Work Order ID 101950

Item Name: Crosstube Fwd High

DRAWING NO. D212-664-141	TITLE XTUBE ASSY (205/212/412 HI FWD)	REV. D	DART AEROSPACE LTD ENGINEERING ORDER		D.E.O. NO. D212-664-141-D-1	SHEET NO. SHEET 1 OF 2	SCALE NTS
DRAWN	CHECKED	OP	MFG. APPR.	RE	APPROVED	WA	DE APPR.
DATE 11.04.07	DATE 11.07.11		DATE 11.04.12		DATE 11/04/12	DATE 11.04.12

DRAWING NO. D212-664-141	TITLE CROSSTUBE ASS'Y (205 HI FWD)	REV. D	DART AEROSPACE LTD ENGINEERING ORDER		D.E.O. NO. D212-664-141-D-2	SHEET NO. SHEET 1 OF 1	SCALE NTS
DRAWN <i>IP</i>	CHECKED <i>ASS</i>	MFG. APPR. <i>AS</i>	APPROVED <i>MD</i>		DE APPR. <i>TH</i>		
DATE 11.07.15	DATE 11.07.20	DATE 11.07.21	DATE 11/07/21		DATE 11.07.21

D212-664-141/-141B
ASSEMBLY DETAIL

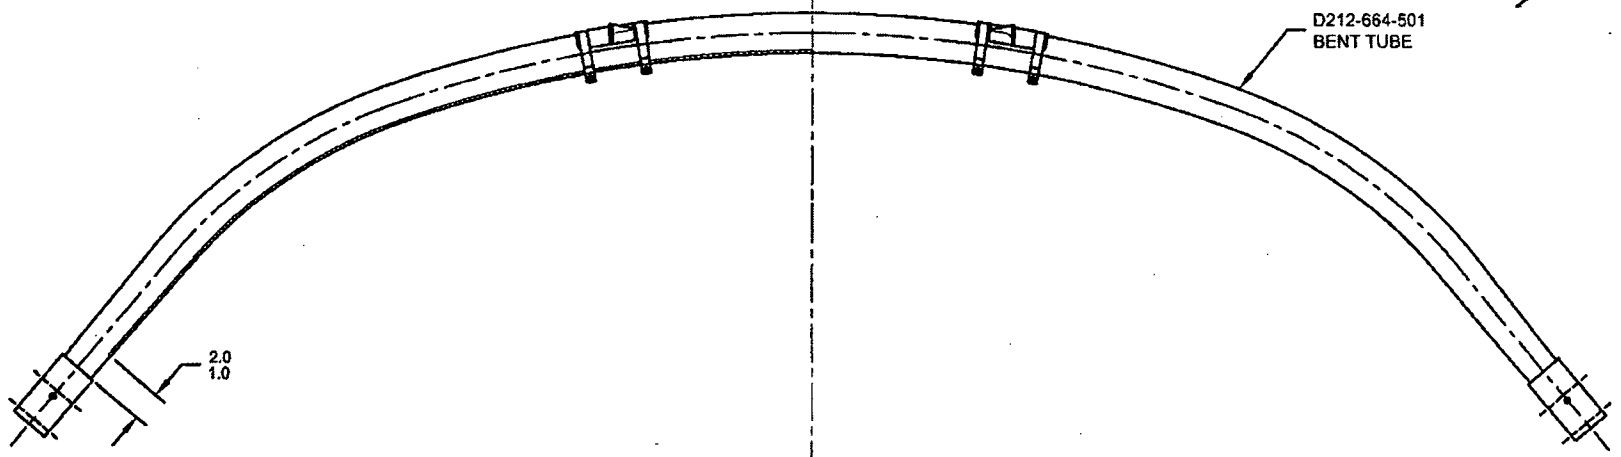
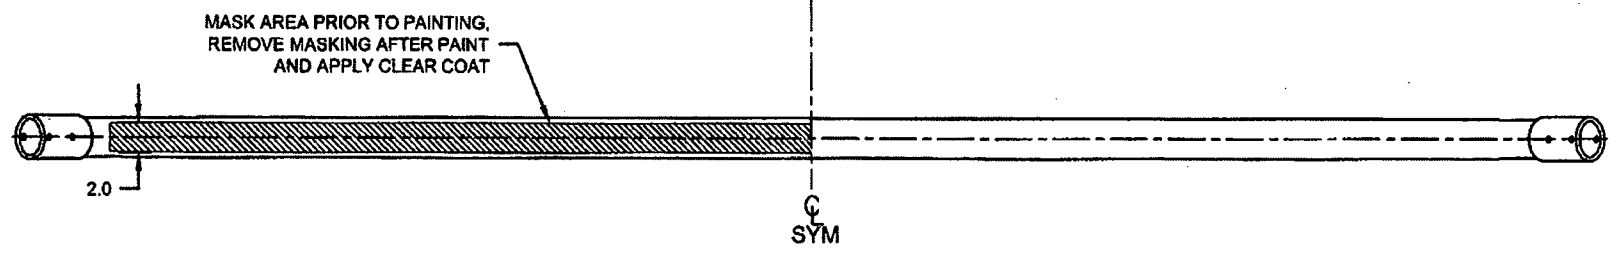
PURPOSE:

ADD AN INSPECTION WINDOW TO UNDERSIDE OF CROSSTUBE.

NOTES 2 OF SHEET 1 IS AMENDED AS FOLLOWS:

IS:

- 2) FINISH: CHEMICAL CONVERSION COAT PER DART QSI 005 4.1
PRIME INSIDE AND OUTSIDE PER DART QSI 005 4.2
MASK UNDERSIDE OF CROSSTUBE AS SHOWN (HATCHED AREA) AND
PAINT OUTSIDE PER DART QSI 005 4.2
REMOVE MASKING AND APPLY CLEAR COAT

WAS:

- 2) FINISH: CHEMICAL CONVERSION COAT PER DART QSI 005 4.1
PRIME INSIDE AND OUTSIDE PER DART QSI 005 4.2
PAINT OUTSIDE PER DART QSI 005 4.2

DRAWING NO. D212-664-141	TITLE XTUBE ASSY (205/212/412 HI FWD)	REV. D	DART AEROSPACE LTD ENGINEERING ORDER		D.E.O. NO. D212-664-141-D-3	SHEET NO. SHEET 1 OF 1	SCALE NTS
DRAWN AJS	CHECKED 9	MFG. APPR. 140	APPROVED 140	DE APPR. 140	DATE 12.06.28	DATE 12.07.05	DATE 12.07.05

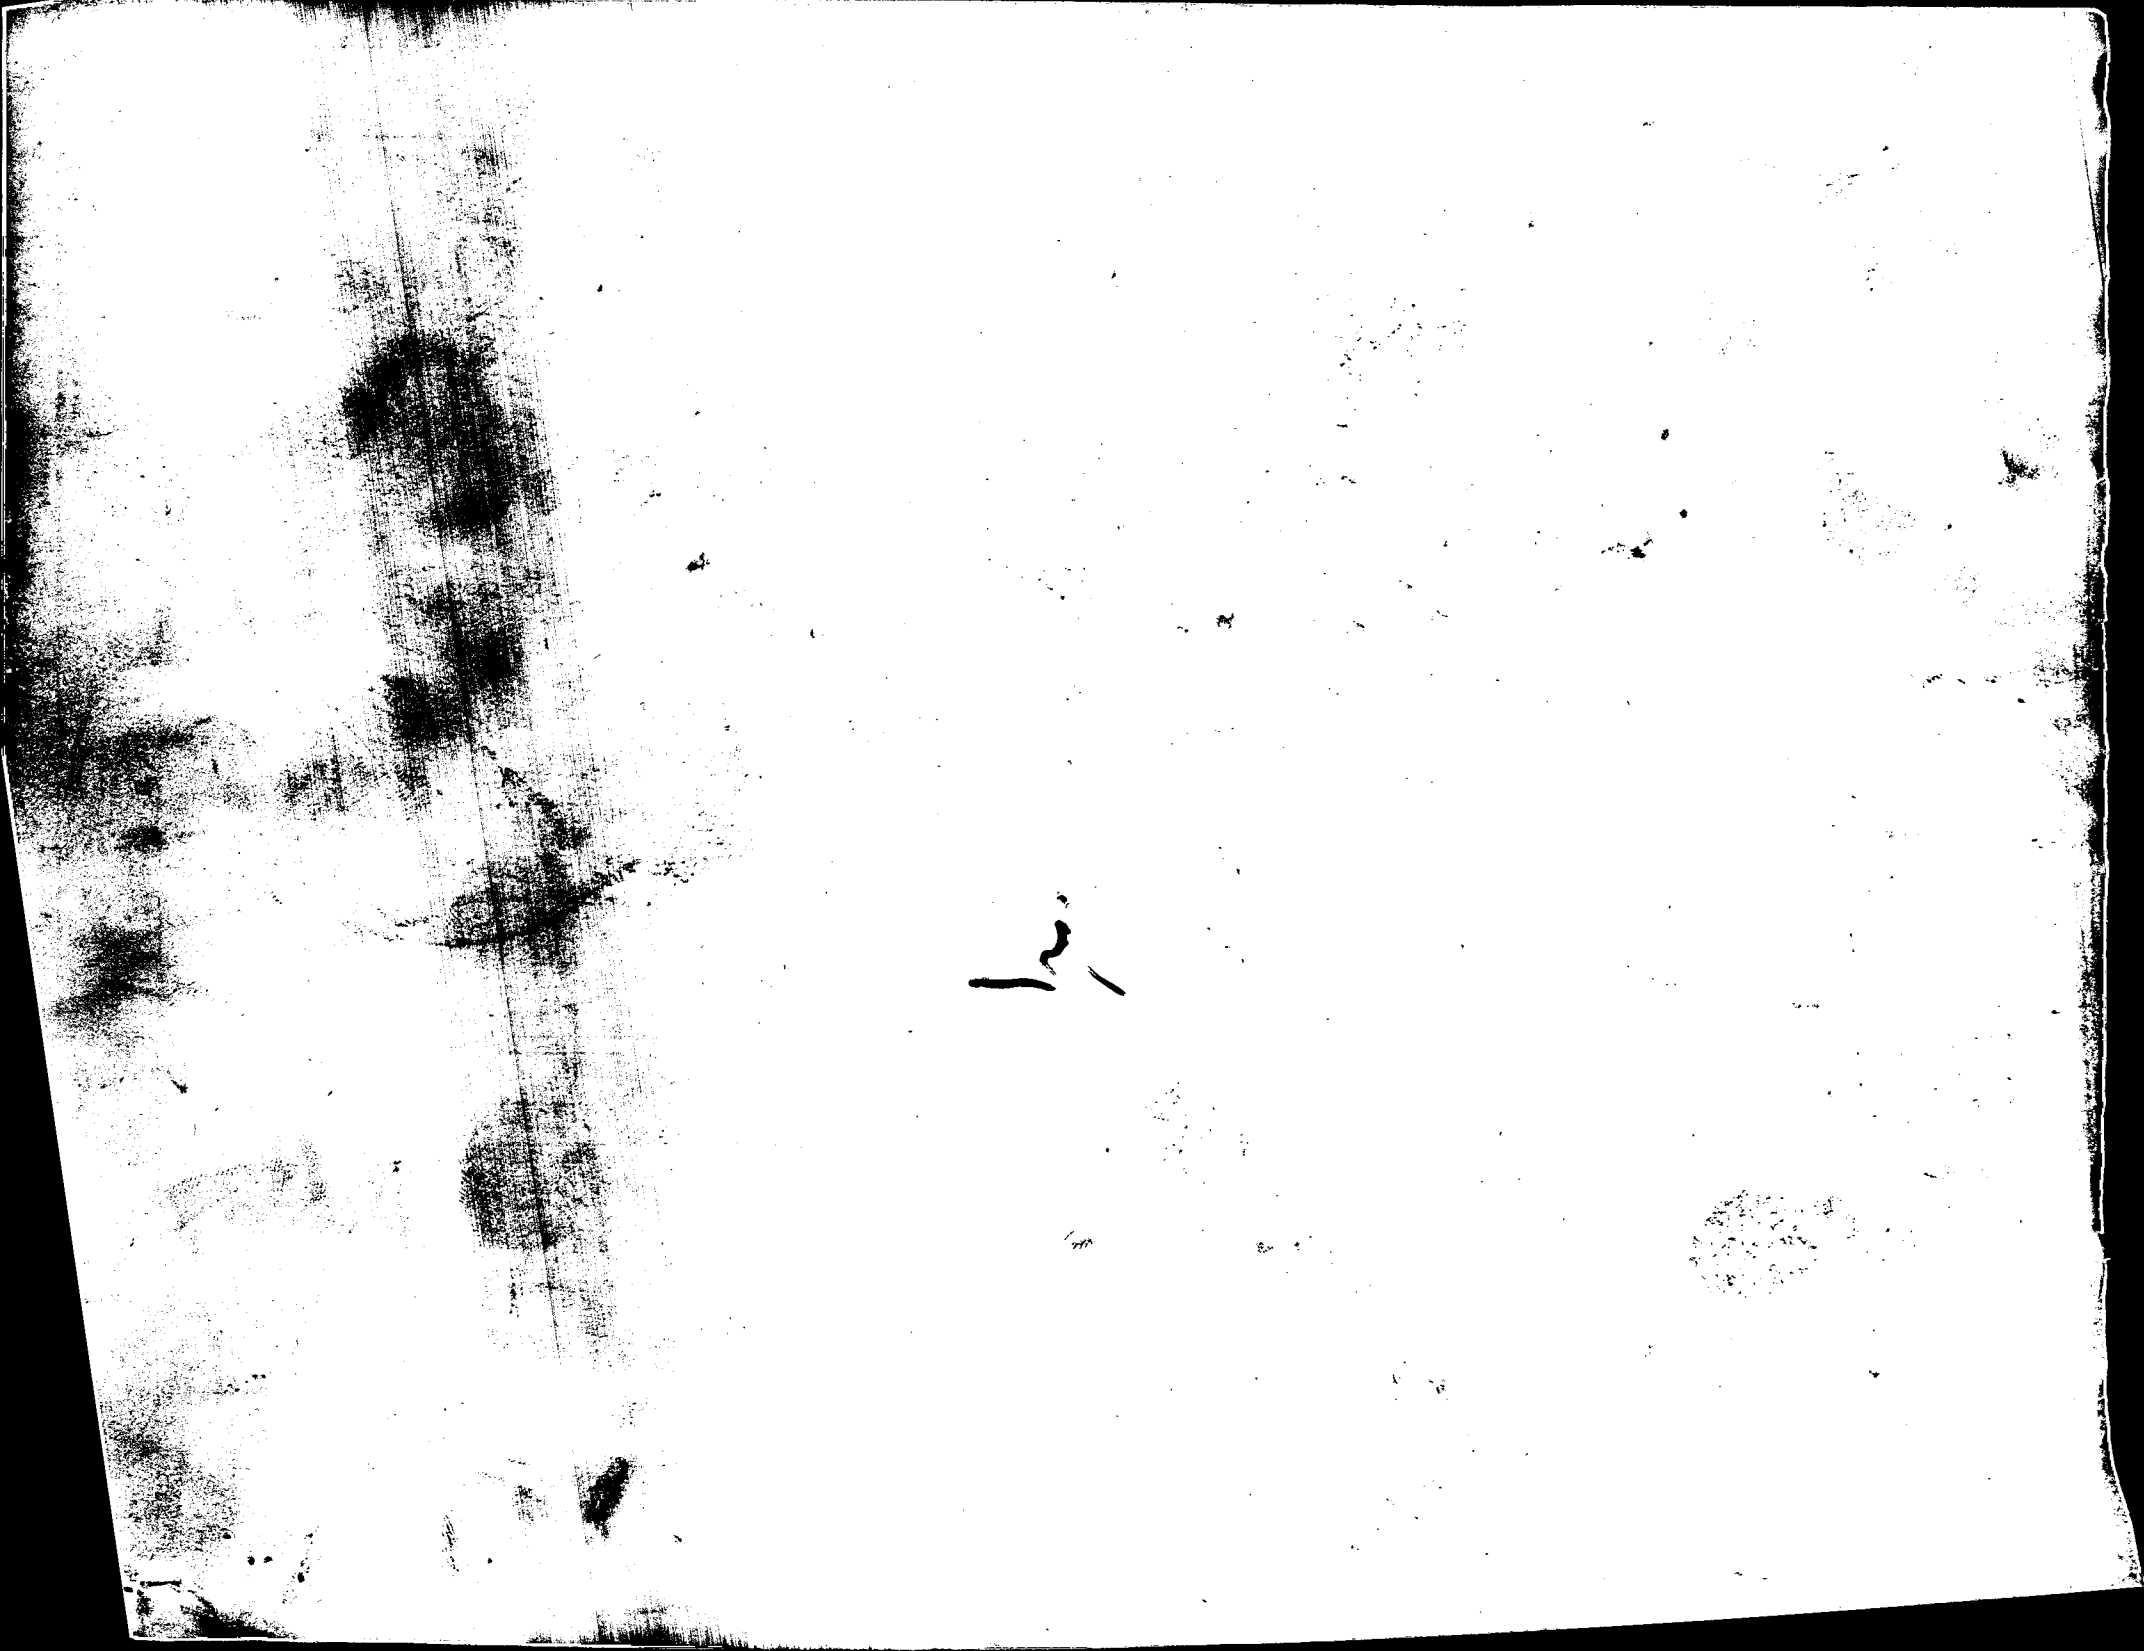
ADD NEW CONFIGURATION WITH ANODIZED FINISH

ADD -141F CONFIGURATION TO PARTS LIST AS SHOWN BELOW:

IS:

- 2) FINISH -141 & -141B ONLY: a) CHEMICAL CONVERSION COAT PER DART QSI 005 4.1
 b) PRIME INSIDE AND OUTSIDE PER DART QSI 005 4.2
 c) MASK UNDERSIDE OF CROSSTUBE AS SHOWN IN DEO D212-664-141-D-1
 d) PAINT OUTSIDE PER DART QSI 005 4.2
 e) REMOVE MASKING AND APPLY MATTE CLEAR COAT

- FINISH -141F: a) ANODIZE PER MIL-A-8625, TYPE II, CLASS 1.
 b) ALODINE (DO NOT ETCH) PER QSI 005 4.1.2
 c) PRIME INSIDE AND OUTSIDE PER DART QSI 005 4.2
 d) MASK UNDERSIDE OF CROSSTUBE AS SHOWN IN DEO D212-664-141-D-1
 e) PAINT OUTSIDE PER DART QSI 005 4.2
 f) REMOVE MASKING AND APPLY MATTE CLEAR COAT

***NOTE:** BETWEEN FINISHING OPERATIONS EXTREME CARE MUST BE TAKEN
 NOT TO CONTAMINATE OR DAMAGE FINISHED SURFACES.

- 2) FINISH: CHEMICAL CONVERSION COAT PER DART QSI 005 4.1
 PRIME INSIDE AND OUTSIDE PER DART QSI 005 4.2
 MASK UNDERSIDE OF CROSSTUBE AS SHOWN IN DEO D212-664-141-D-1
 PAINT OUTSIDE PER DART QSI 005 4.2
 REMOVE MASKING AND APPLY CLEAR COAT
